No. 80-8

Power Trim Hose Installation to Reverse Lock Valve

(Attach Bulletin Reference Sticker to P. 7A-8 of Your Service Manual.)

Figure 1. Seal Plug Location

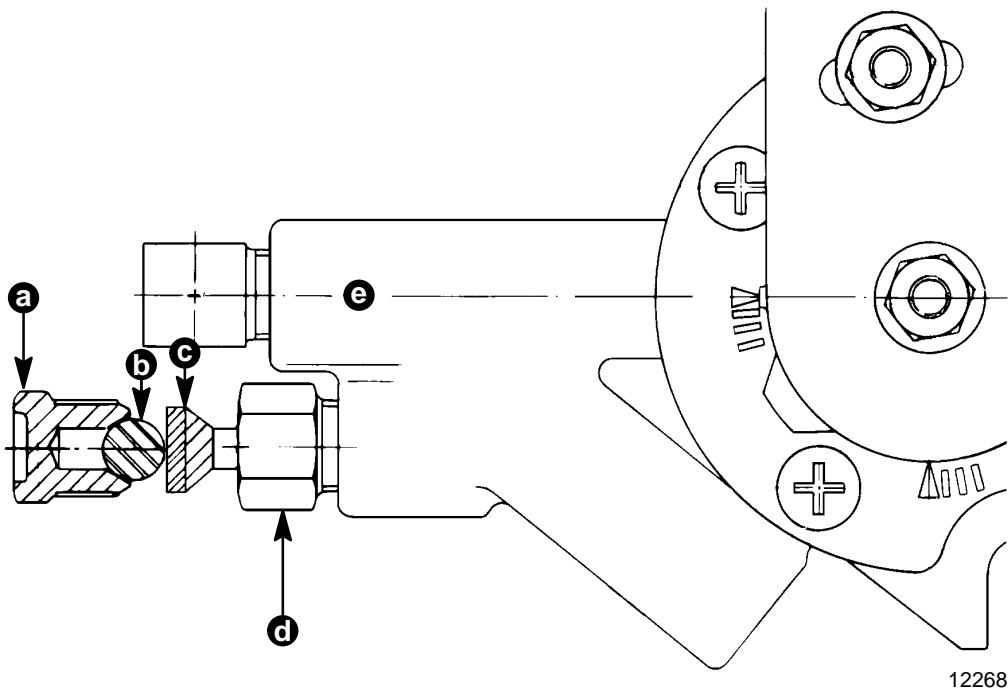
Some V-8 engines (898/228/260) reverse lock valve assemblies were produced with an extra seal plug (Figure 1) in straight fitting to which white plastic tubing connects. This plug must be removed, along with shipping plug and ball.

If plug is not removed, Power Trim will not operate hydraulically in “up” or “down” direction. Future reverse lock valve assemblies again will have only the shipping plug and ball installed.

Figure 2. V-8 Power Steering with Locking Spring

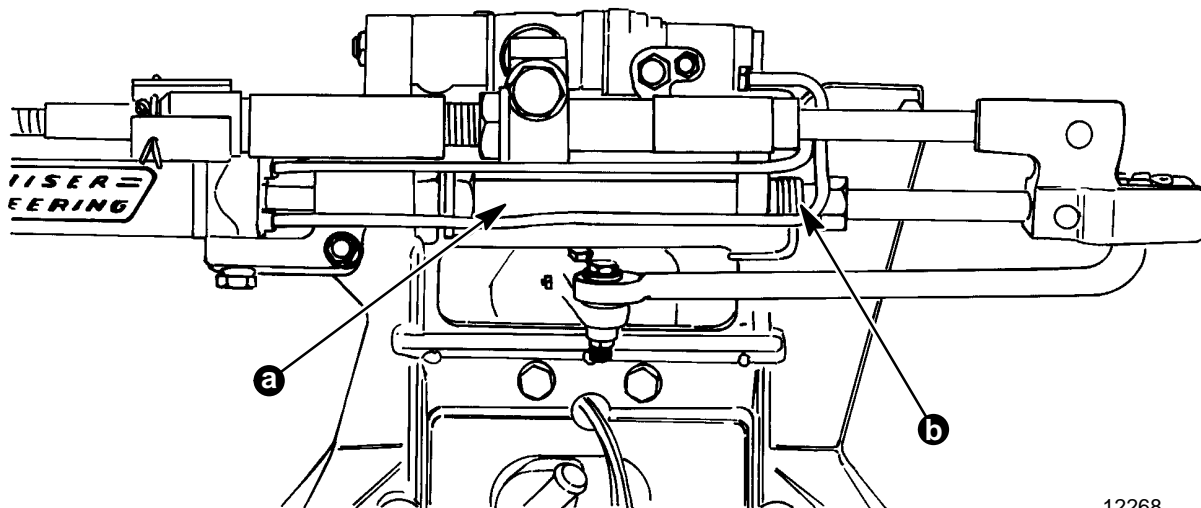
When servicing V-8 Power Steering that does not have a locking spring (24-78498) installed on its mounting tube, install one of the locking springs during reinstallation of the Power Steering assembly to transom. (Figure 2)

Figure 3. Dual Drive Installation with Single MerCathode

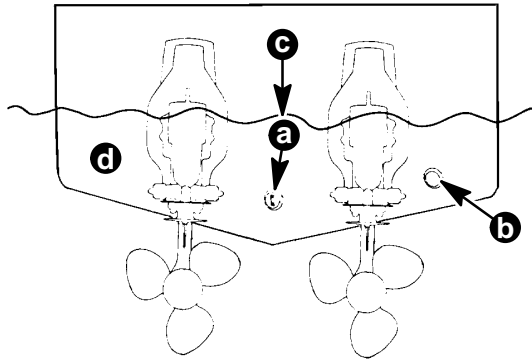
When installing a MerCathode on a boat with dual drive units (Figure 3), the anode is installed between the drives (below waterline), and the reference electrode is installed on outside of either drive (below waterline). This location will protect both drive units.

Figure 4. Dual Drive Installation with Dual MerCathode

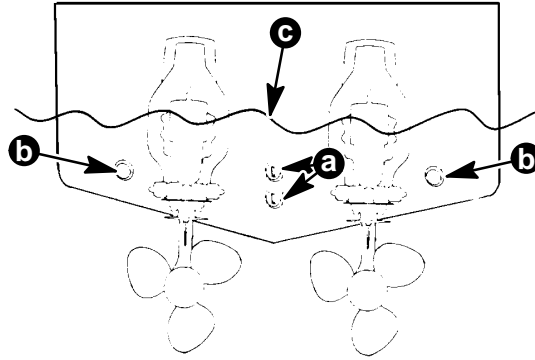
When installing two (2) MerCathode systems on a boat with dual drive units (Figure 4), both anodes are installed between the drives (below waterline), and reference electrodes are installed on outside of each drive unit (below waterline).

Figure 7. Old Method of Measuring (54121A10 Cable)

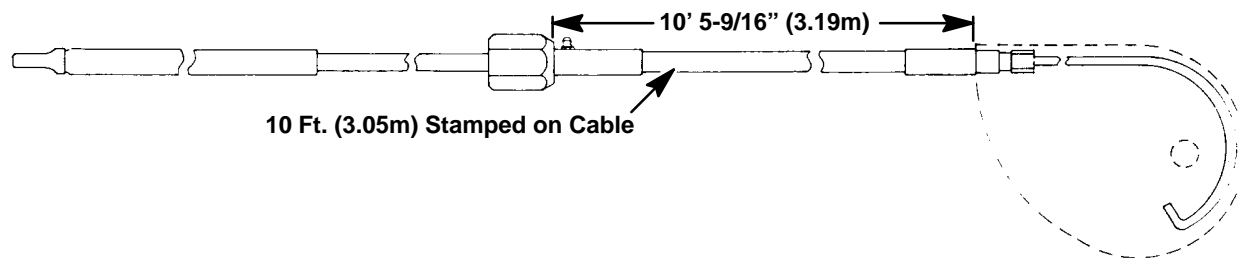
Example: 54121A10 cables were measured the old way (from cable fastening nut to housing) and had old measurement (10 ft.) stamped on cable housing. That cable is interchangeable with 76042A12 cable which is measured the A.B.Y.C. way (from centerline of steering wheel to hole in output end of ram with steering at mid-travel) and has new measurement (12 ft. 6 in.) stamped on cable housing.

Figure 8. A.B.Y.C. Method of Measuring (76042A12 or 76876A12 Cable)

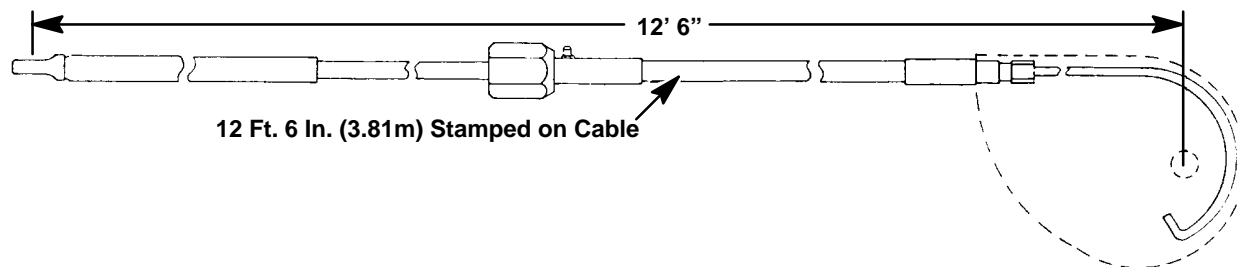
Cable and head assembly 76876A is not interchangeable with 76042A__ or 54121A__, because of differences in head, however, both 76876 and 76042 cables are measured and stamped on cable housing by A.B.Y.C. standards.
